Economic and Social Council

Group of Experts on the Permanent Identification of Railway Rolling Stock

Model Rules on Permanent Identification of Railway Rolling Stock

Transmitted by the Rail Working Group

Visualisation (Option 1):

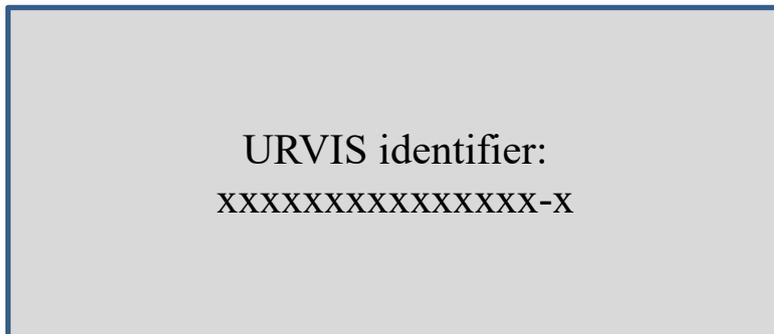
11. In the appendix to the attached draft, we have left open for debate three alternatives as to how the initial plate should appear. Option 1 is the cheapest and simplest option, but the other options would be more desirable through giving uninformed observers a clear explanation of the purpose of the marker. Alternatively, the Rules could leave the three options in as alternatives for the parties to choose.

[Option 1: the URVIS identifier only, i.e. “URVIS identifier: xxxxxxxxxxxxxxxx-x”
